STATE OF CONNECTICUT
CONNECTICUT SITING COUNCIL

APPLICATION OF HOMELAND TOWERS, LLC
(HOMELAND TOWERS) AND NEW CINGULAR
WIRELESS PCS, LLC (AT&T) FOR A CERTIFICATE
OF ENVIRONMENTAL COMPATIBILITY AND
PUBLIC NEED FOR THE CONSTRUCTION,
MAINTENANCE AND OPERATION OF A
TELECOMMUNICATIONS TOWER FACILITY IN
RIDGEFIELD, CONNECTICUT

DOCKET NO. 445

**HOMELAND TOWERS, LLC and NEW CINGULAR WIRELESS, PCS LLC (AT&T)
RESPONSES TO RACT INTERROGATORIES**

AT&T Stand-Alone Coverage at Ridgefield, CT with S1855 @ 150' AGL

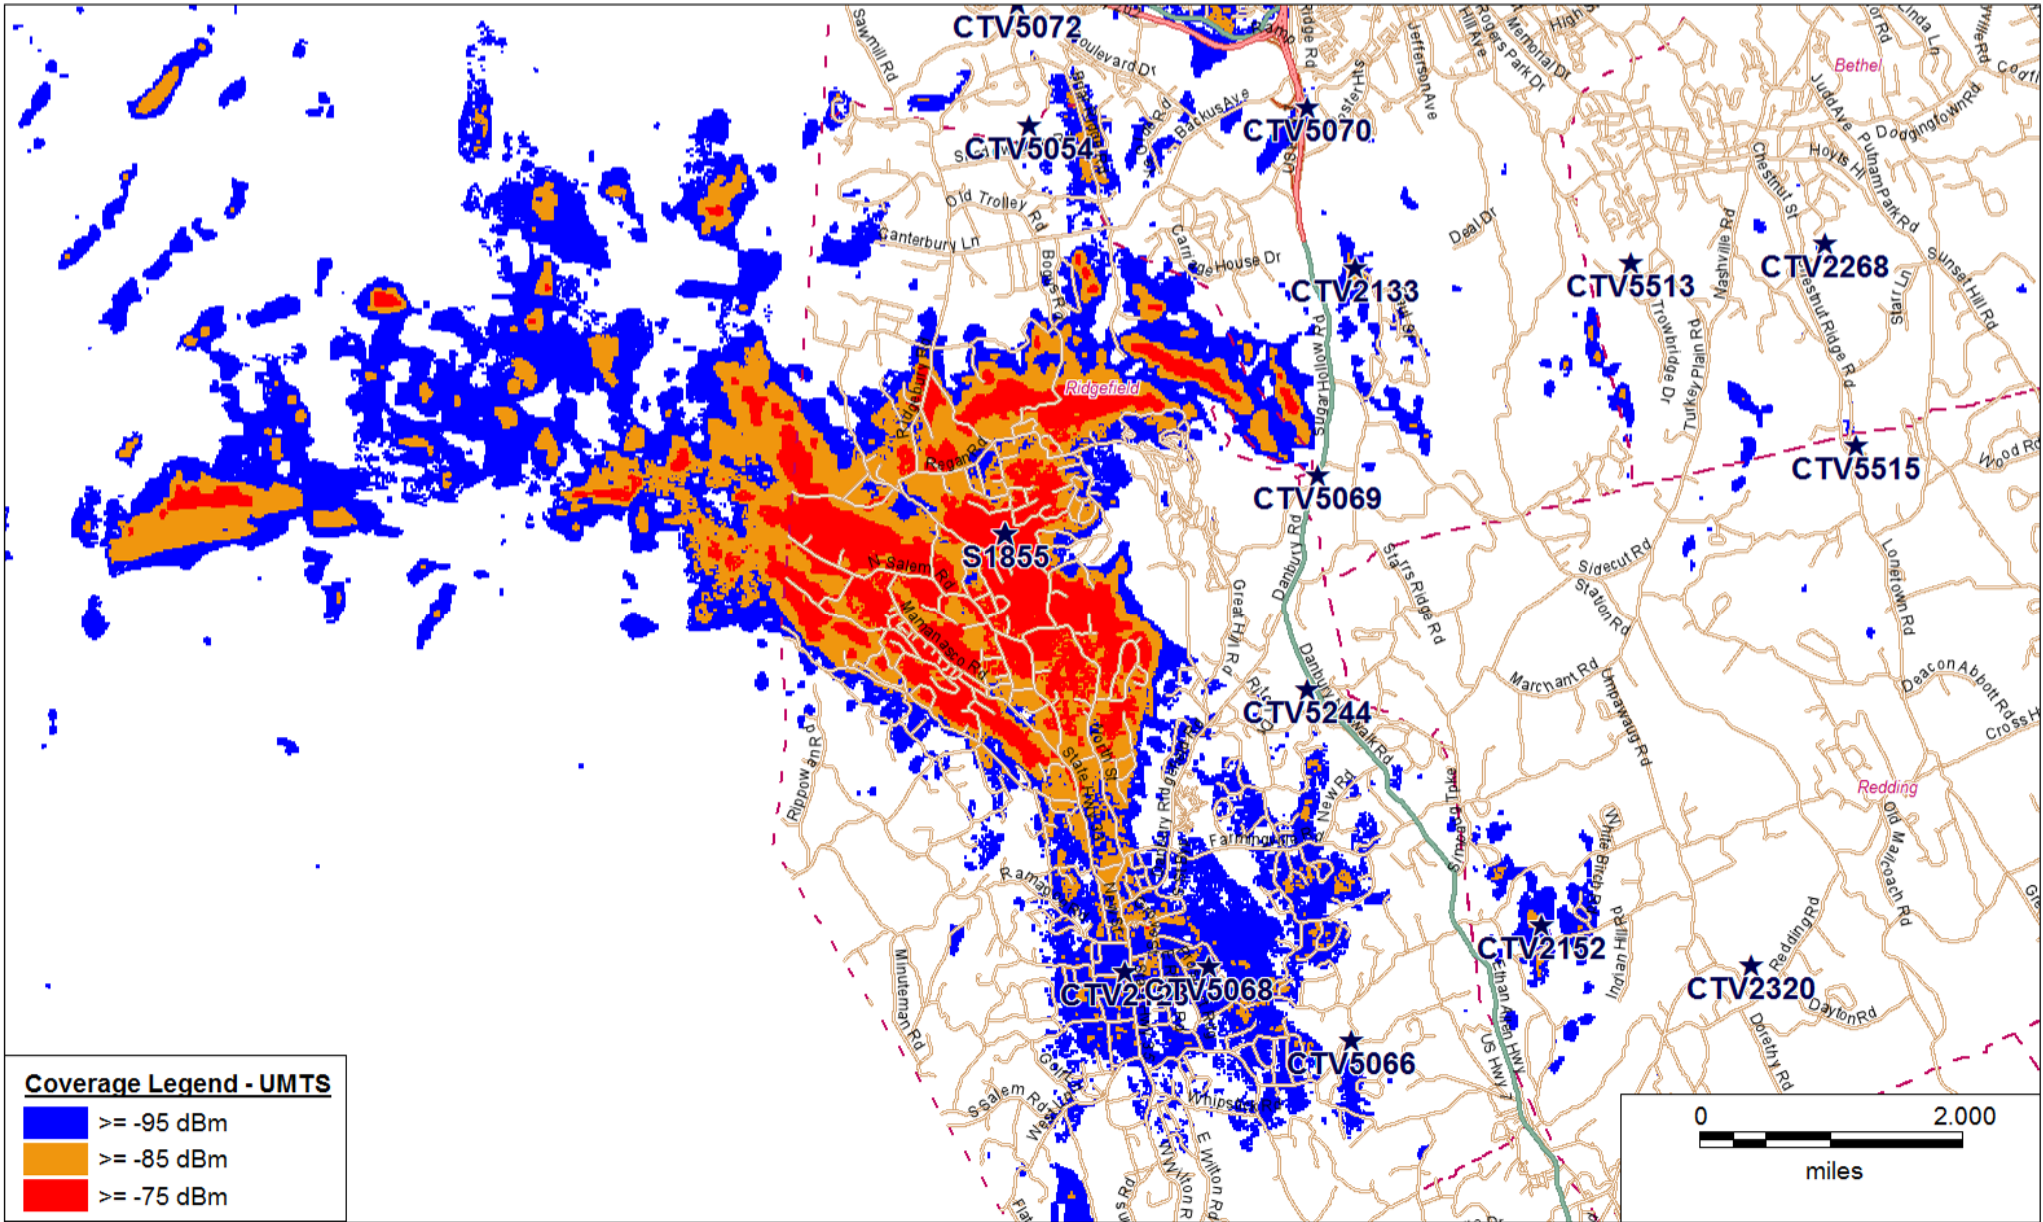
Q37. Can you provide coverage propagation maps and isolated propagation maps for the proposed facility on clear plastic overlays using a scale that matches that of the Application at 4 dBm intervals?

- A37. *Attachment 2 provides a color copy of a plot at 850 Mhz with thresholds from -75 to -95 at 10 db increments. 4 dBm intervals are difficult to read at the scale and the plots in the Application already have an 8 dBm interval (ie. -74 to -82). To the extent RACT seeks to have plastic overlays of the attachment made or further plots prepared, the Applicants respectfully submit that their consultant Mr. Maxson should provide those services to RACT.*
